TECHNICAL ADVISORY REPORT

IN SUPPORT OF THE JOINT LETTER OF INTENT
FOR TATA STEEL NETHERLANDS

Date of publication: 29 September 2025

Figure 9. Predicted CO₂ emissions per (sub)project [6]

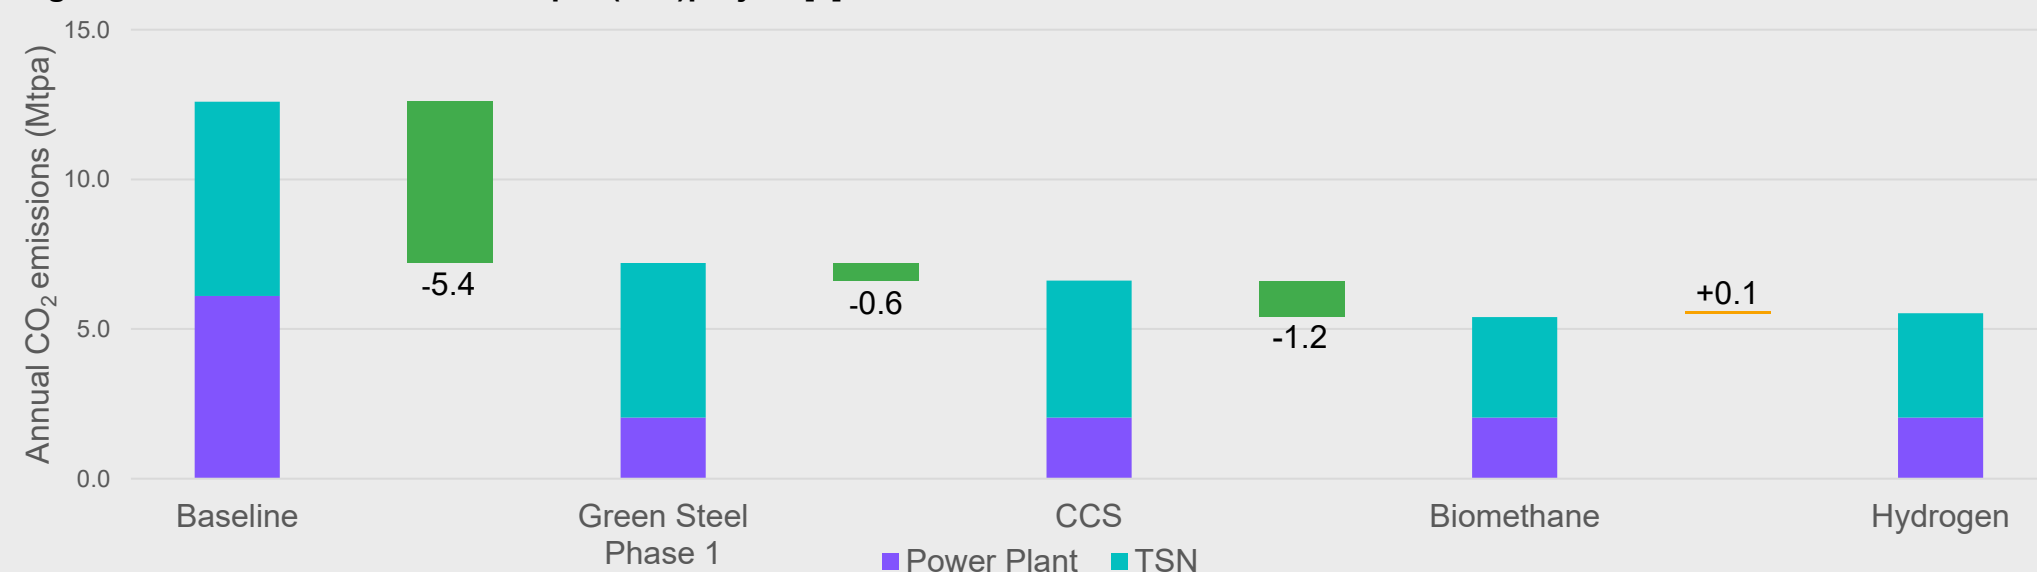
To calculate CO₂ emissions, TSN uses its in-house Carbon (reduction) Selection Model (CSM) which is based on carbon mass-balance principles and historical data for the existing assets. The material flows for the new assets (DRP-EAF) are sourced from databooks provided by the Original Equipment Manufacturers (OEMs). Overall, the methodology is considered appropriate and in line with industrial best practice. However, some uncertainties are identified:

- Only the major assets onsite are included.
- Minor carbon flows (e.g. scrap and steel products) are excluded.
- Only CO₂ is included; other greenhouse gasses are omitted.
- The coking time of CGP1 will increase once Green Steel Phase 1 is implemented. This operational change can impact the material balance over CGP1, but is not completely reflected in the calculations.
- Some consumption factors in the CSM differ from source documents.

A margin of 0.6 Mtpa has been agreed upon in the JLoI. This margin is considered sufficient to allow for any of the above-mentioned uncertainties to materialise. Therefore, it is likely the stated CO₂ objectives in the JLoI can be achieved with Green Steel Phase 1. The scope of this review only covers scope 1 emissions, scope 2 and 3 emissions are specifically not part of this review.

Figure 11. TSN's predicted PM₁₀ immission contribution reductions in WaZ [6]

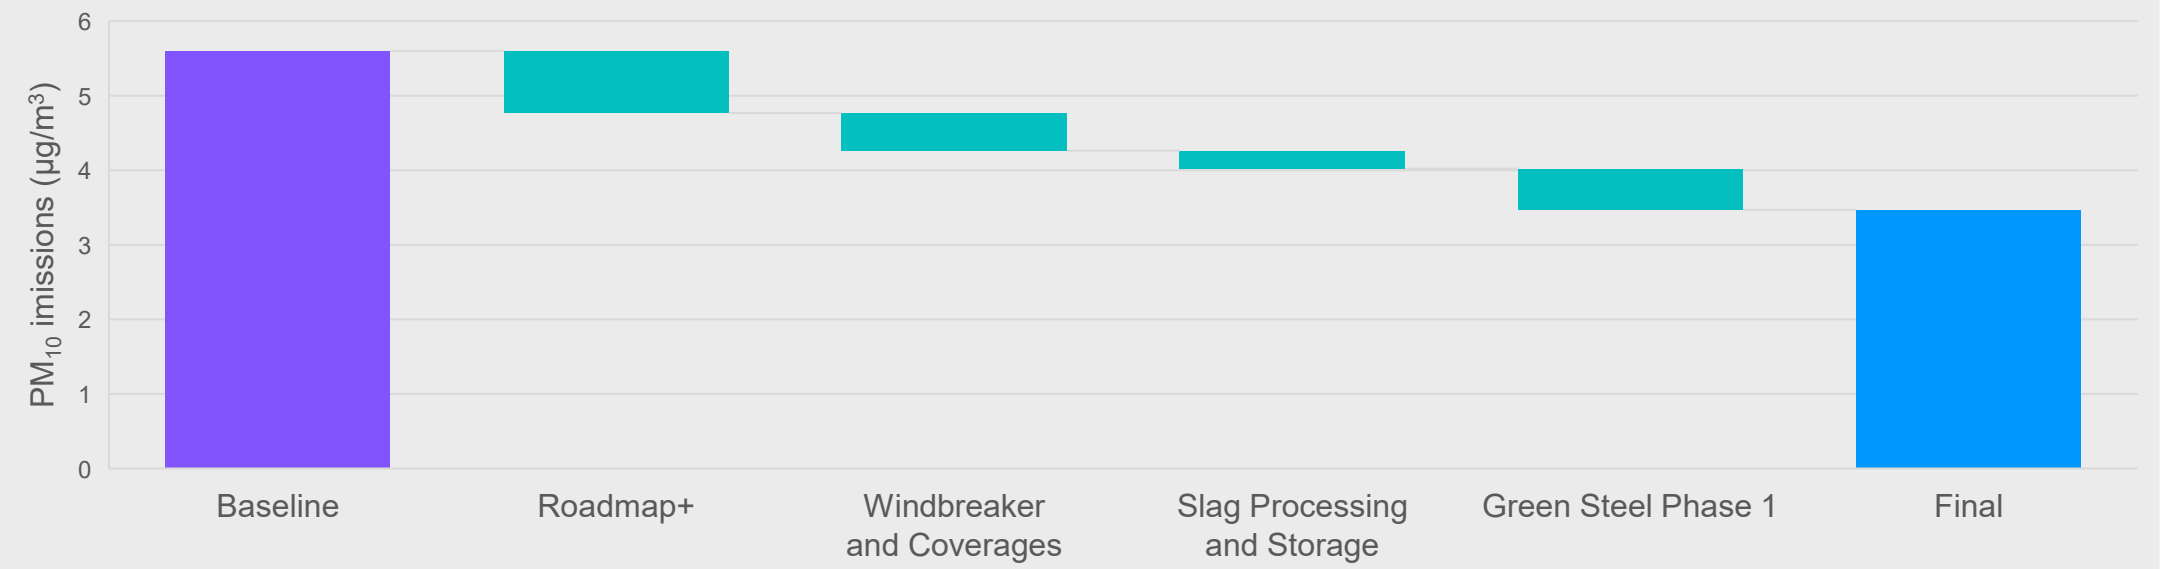
TSN estimates its 2019 baseline immission contribution in WaZ at 5.6 µg/m³, including chain partners Harsco and PHY. To meet the 35% target, a reduction of approximately 2.0 µg/m³ is required (Figure 11). TSN predicts a 38% reduction (2.1 µg/m³) through combined measures (reduction percentages and totals may differ due to rounding):

The PM₁₀ immissions have been calculated using TSN's emissions data and dispersion industry-standard dispersion modelling software. While this approach aligns with industry best practice, and dispersion modelling is the appropriate tool for predicting future immissions, this introduces additional uncertainty such as not being able to predict future meteorological conditions and how the model calculates pollutant dispersion. Independent baseline immissions estimates by RIVM, derived from alternative modelling and monitoring data analyses, range from 4.6 to 7.4 µg/m³. TSN's baseline immission estimate of 5.6 µg/m³ falls within this range. However, the spread of values highlight the inherent uncertainty in immission modelling.

Figure 12. PM₁₀ immission reduction in WaZ from the Windbreaker and Coverages [6]

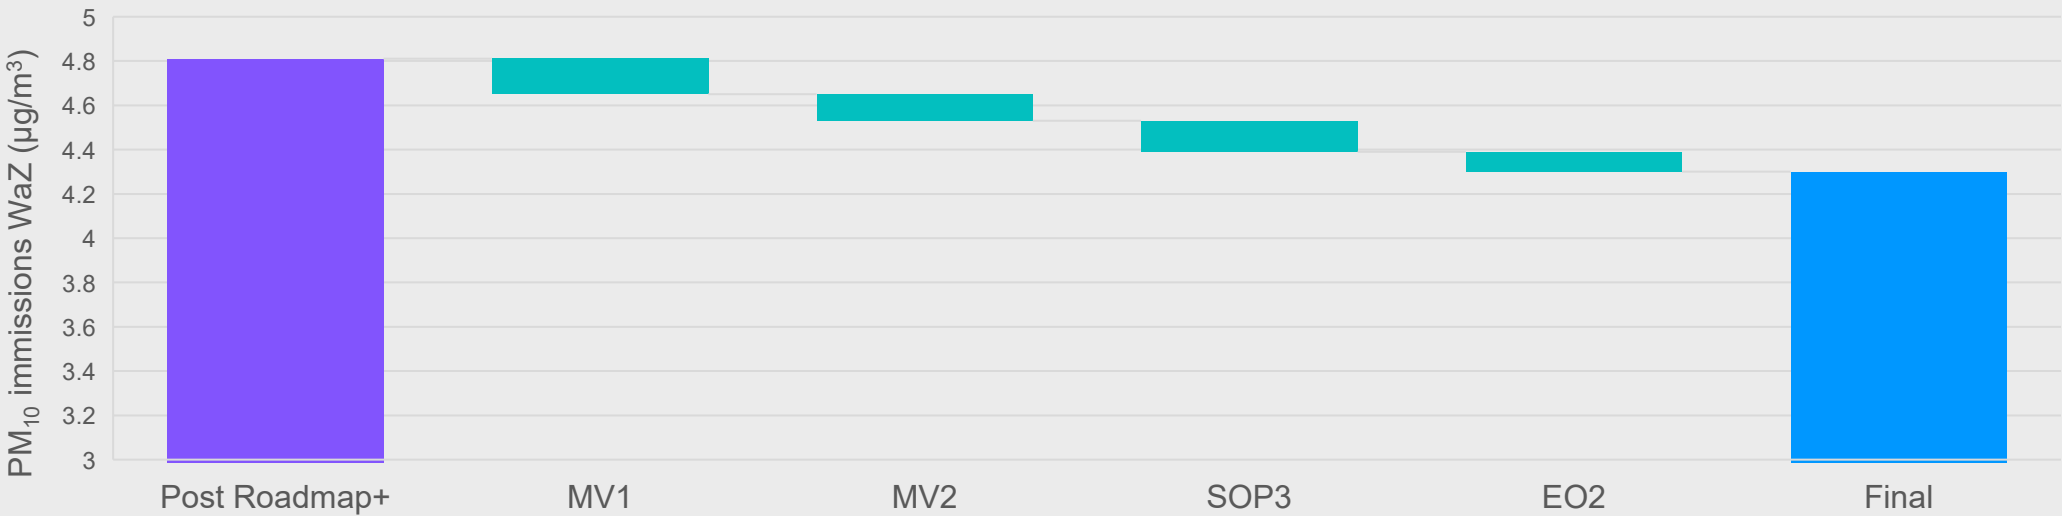
Measures include a windbreaker at MV1 and coverages at MV2, EO2, and SOP3. These are predicted to reduce PM₁₀ immissions by ~0.5 µg/m³ (~9%) (see Figure 12). As detailed on page 15, TSN's calculations have used emission factors from national guidance and dispersion modelling by an independent consultant. Reduction factors applied (90% for full coverages and 50% for the windbreaker) are supported by published literature and wind simulation data. This methodology aligns with industry best practice, however the predicted reductions are subject to uncertainty due to the cumulative effects of:

Figure 18. Two Water Granulation Concepts [16]

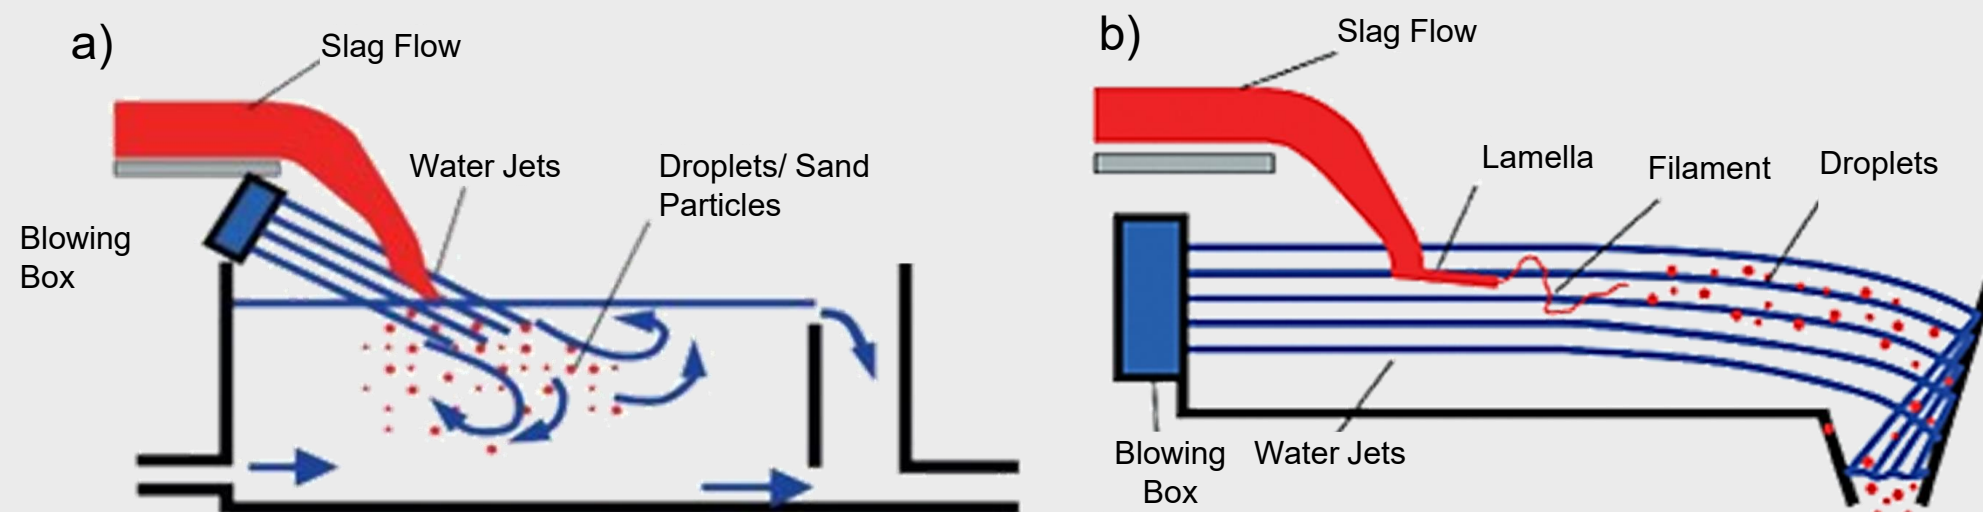
TSN has selected water granulation as the preferred processing method after evaluating alternatives. This process rapidly cools molten slag with water jets to form glass-like granules (Figure 18). TSN currently uses water granulation for blast furnace slag, which is widely used as SCM.

Future regulatory changes on heavy metals could significantly impact the viability of slag applications. TSN has acknowledged that stricter limits on chromium and vanadium could pose a major challenge.

TSN's slag processing and application plan is in early stages of development. The current plan relies on a technology and application pathway that is not yet proven at the required scale. Significant challenges and uncertainties remain regarding technical feasibility, certification, and environmental compliance. A clear and detailed development roadmap, supported by OEM commitments and independent testing, will be essential to reduce these uncertainties. Due to the uncertainties with water granulation, TSN is engineering quench cooling as fallback option, which is considered a more proven technology, although challenges with SCM application remain.

Figure 19. Phase-by-Phase and Total CapEx for Green Steel Phase 1 [6]

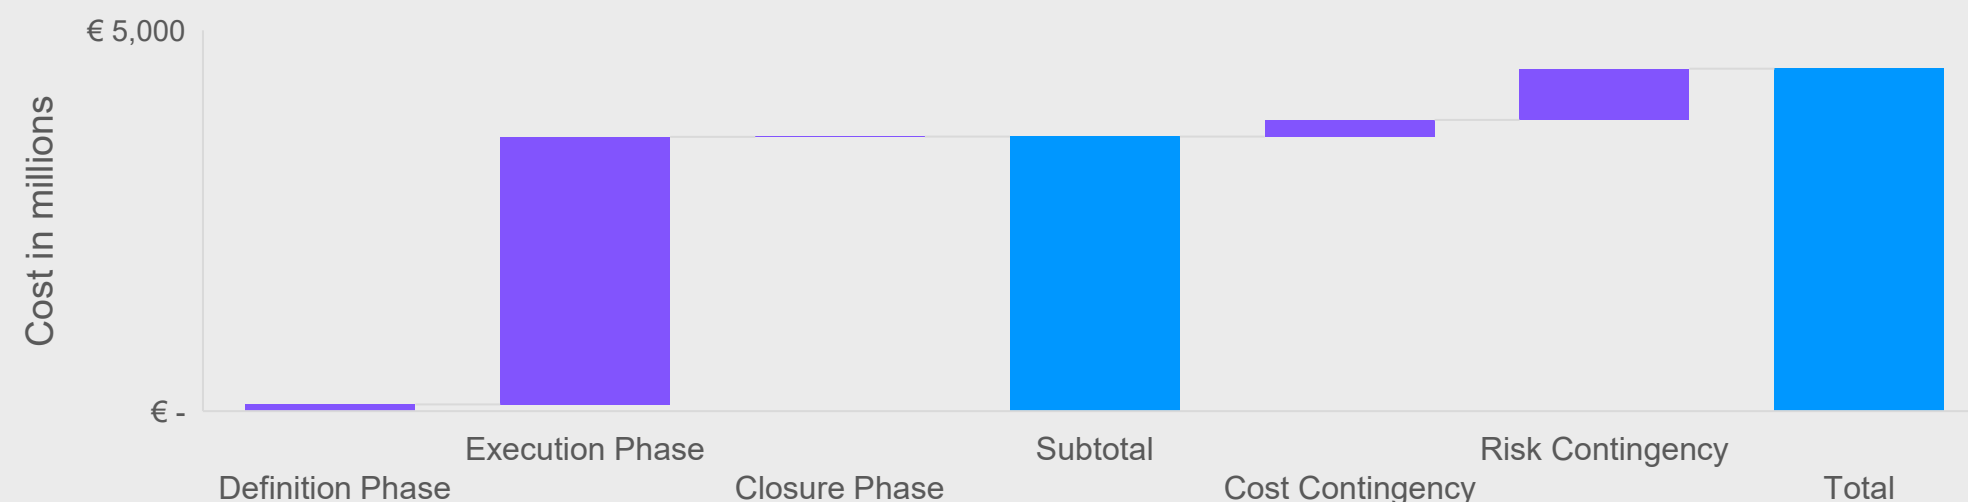
- **Cost contingency:** TSN has included 6%, which is considered low given the level of definition. A contingency of ~10% would be more appropriate.
- **Risk contingency:** Currently 19%, based on an outdated risk assessment, but considered broadly reasonable.

Figure 20. CapEx estimate Windbreaker and Coverages [6]

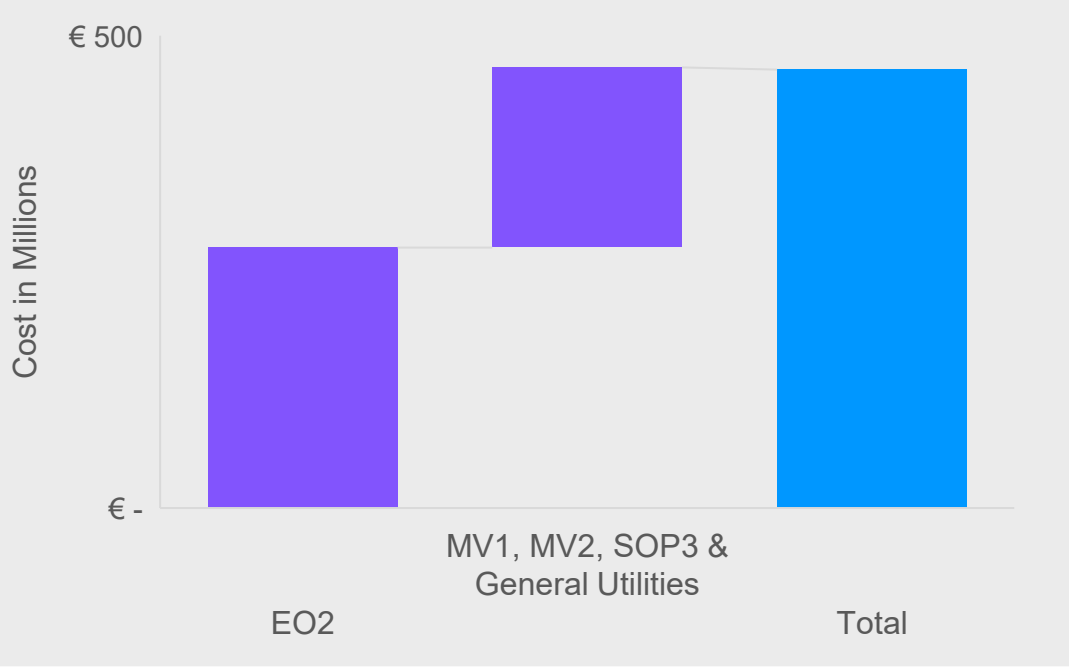
TSN’s total CapEx allowance for the Windbreaker and Coverages project is approximately €465 million, divided across four main storage areas (EO2, MV1, MV2, SOP3) and General Utilities (Figure 20). The estimate is structured as follows:

EO2 accounts for 60% of total project costs (~€275 million) and is at FEL1/2 maturity. Current contingency is 17%, which is low given the early stage and identified issues. A contingency of 25% is considered more appropriate. As this estimate accounts for 60% of the total programme costs, this significantly affects the total integrity of the cost estimate.

Figure 21. Accuracy of the CapEx estimates per asset [6]

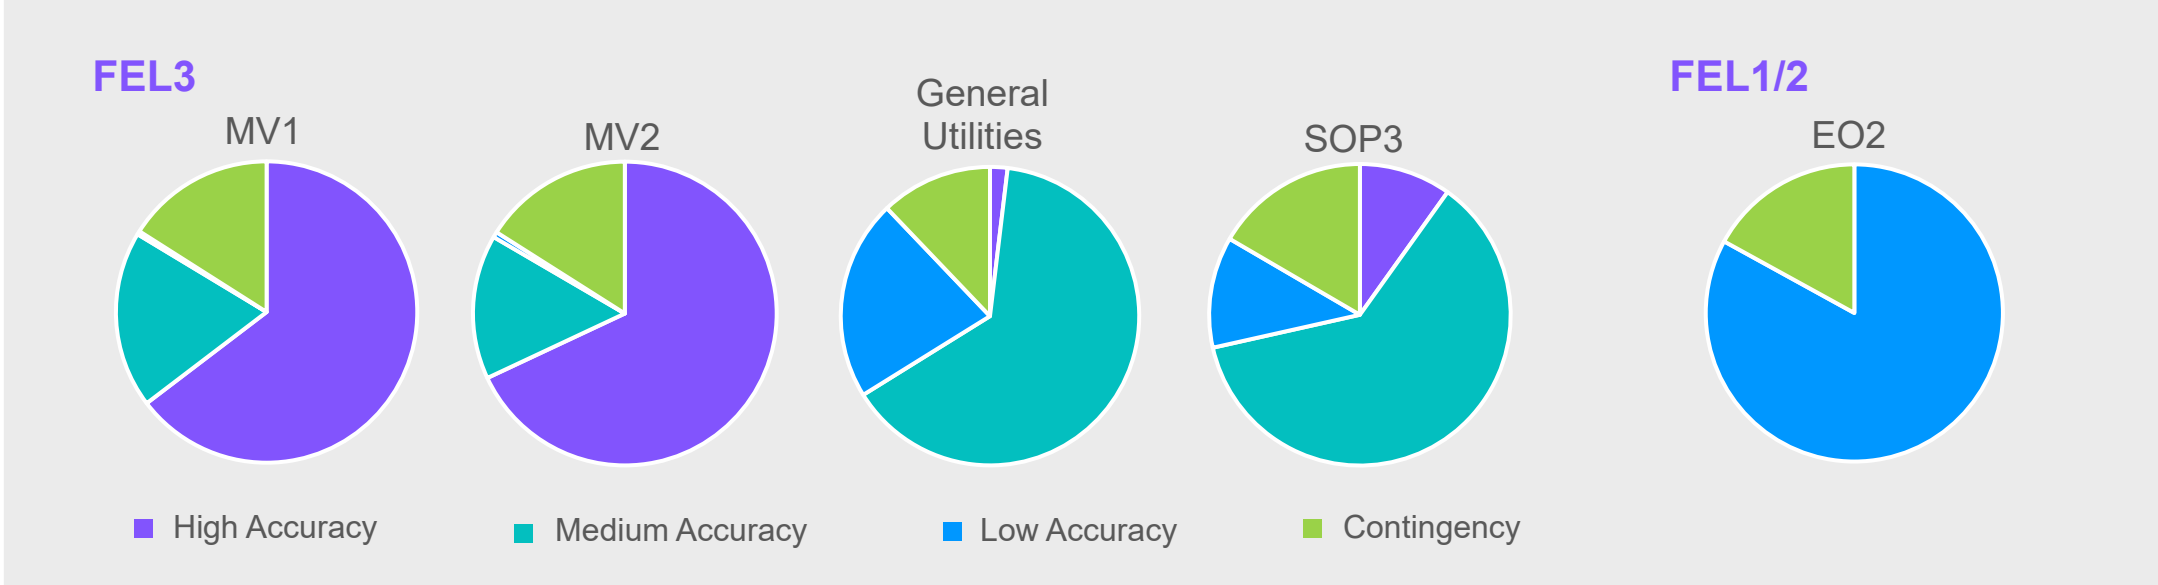
- **MV1 and MV2:** Data accuracy is medium to high (Figure 21), supported by budget quotes and benchmarks.
- **SOP3 and General Utilities:** Data has a lower accuracy, with limited breakdowns and reliance on in-house estimates. No detailed breakdown was provided for project management office costs, which introduces uncertainty.
- **Contingency:** for general utilities is lower than for other areas, despite higher uncertainty.

Figure 22. Total CapEx Slag Processing and Storage [6]

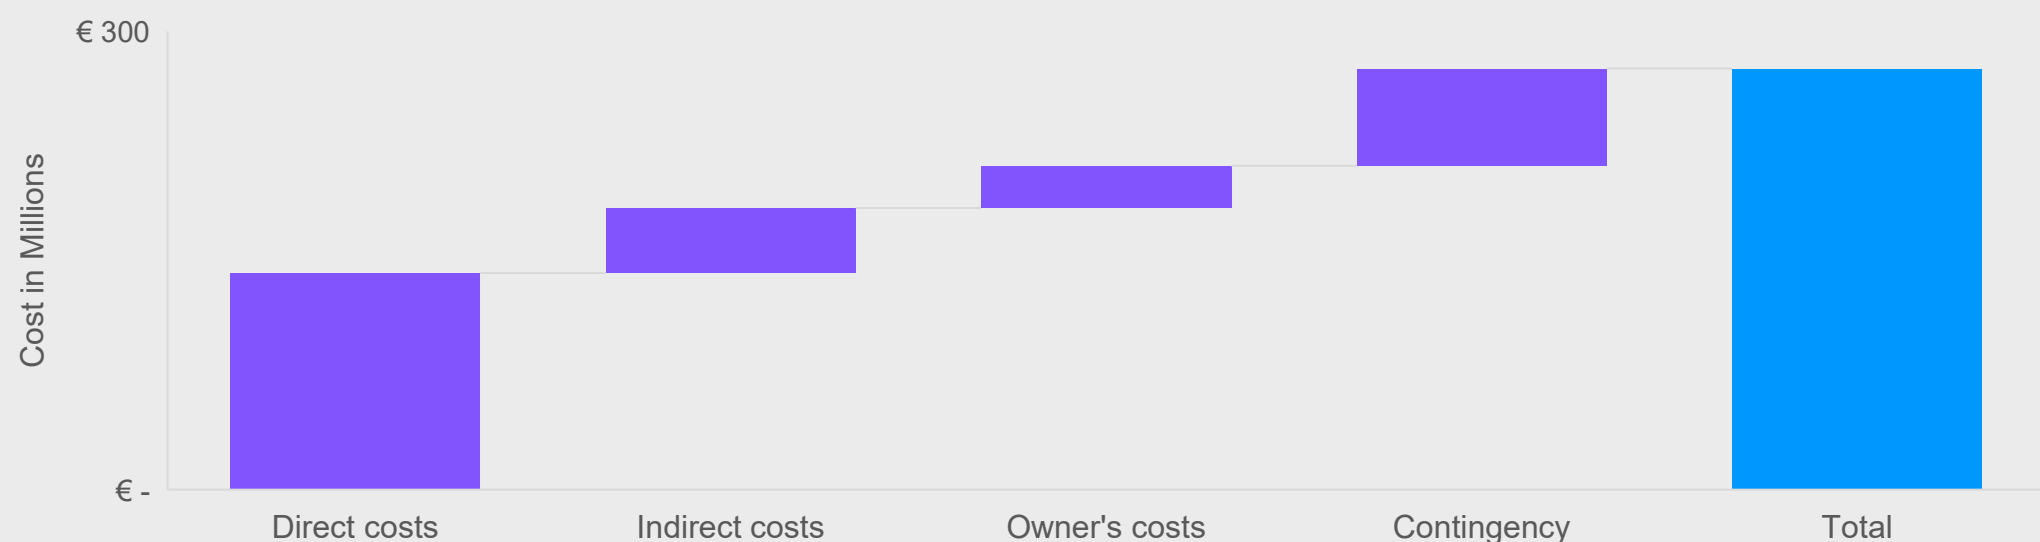
The estimate uses historical data from similar systems. The proposed flow rate is 500,000 m³/h, with the estimate scaled down from larger reference plants. The approach is considered reasonable.

A contingency of 30% is applied to the total estimate. This is in line with expectations for FEL1 maturity.
